RHO/RMS/EP
OPERATIONS CHANGE NOTICE

OCN No. 1590

- a. Title: "Model 1500 Loading Procedure"
- b. Chapter and Section: XIX Revision 11/16/92 Page(s) Attachment I
- c. Form No.: N/A Revision Code N/A

ATTACHMENT I

SK98026

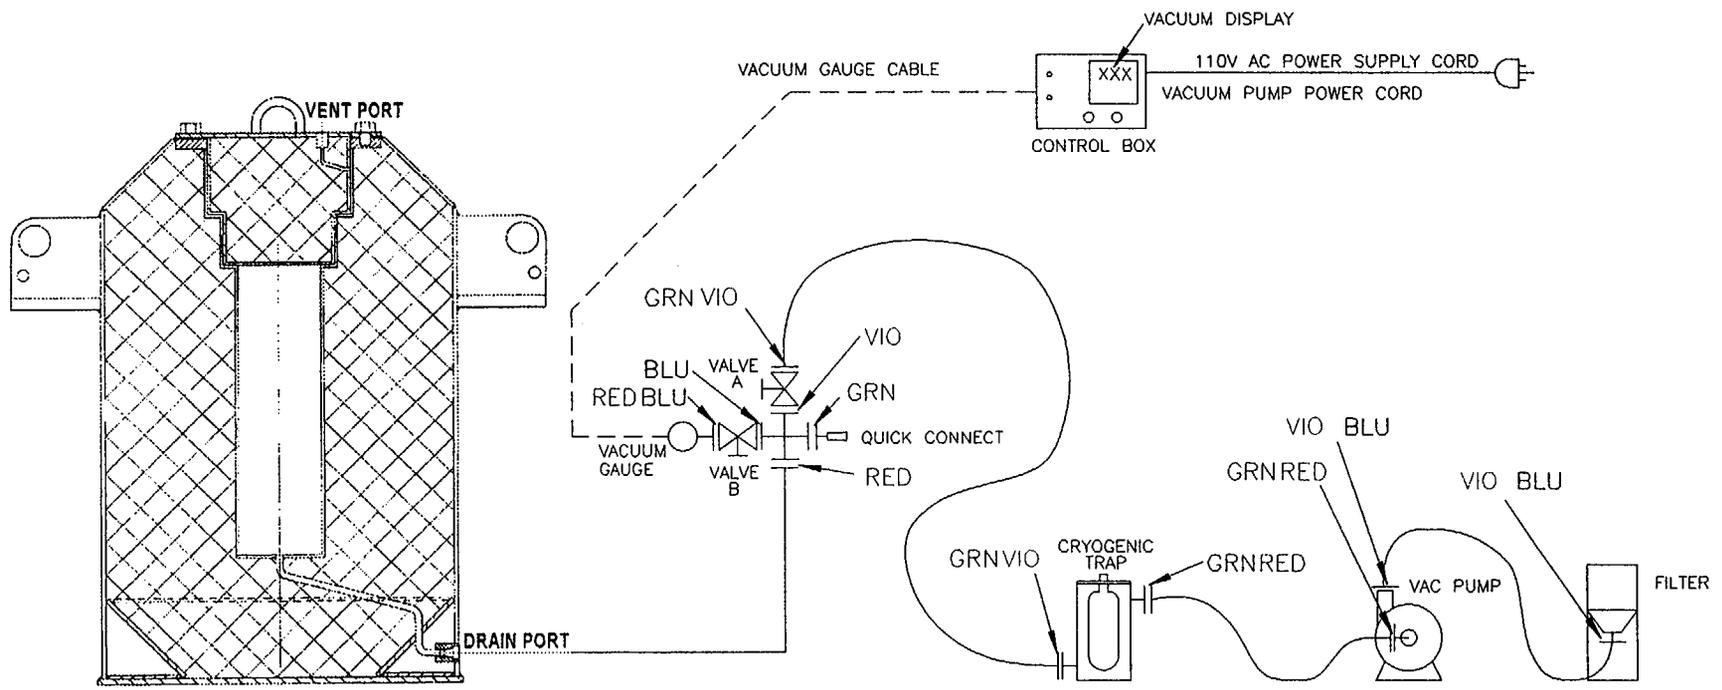
- a) Delete current 3-page Attachment I, (Vacuum Drying Procedure, Cask Cavity Drying Procedure, and Model 1500 drawing). Replace with new 2-page Attachment I (Vacuum Drying Procedure and Model 1500 drawing).
- b) First paragraph "Note"; change to read: "... (A) the cask cavity has been drained of water, (B) the drain line is unobstructed by observing the quality of the stream, (C) all lid bolts have been installed and torqued according to procedure, and (D) vent port pipe plug has been installed and tightened."
- c) Step 3, change to read: "...vacuum gauge, valve and quick disconnect as shown in the diagram."
- d) Step 10, change 15 torr to 3 torr.
- e) Step 11, change first sentence to read: "...pressure reads less than 1.0 torr for a period of no less than 30 minutes."

- ***| 3. Attach color-coded tee, vacuum gauge, valve and quick disconnect as shown in the diagram.
4. Connect color-coded vacuum hoses between valve, cryogenic trap (cryogenic trap must be dry inside and lid snug), vacuum pump, and HEPA filter. See diagram.

To add clarification to the procedure and to incorporate the requirement for a longer evacuation period below 1.0 torr.
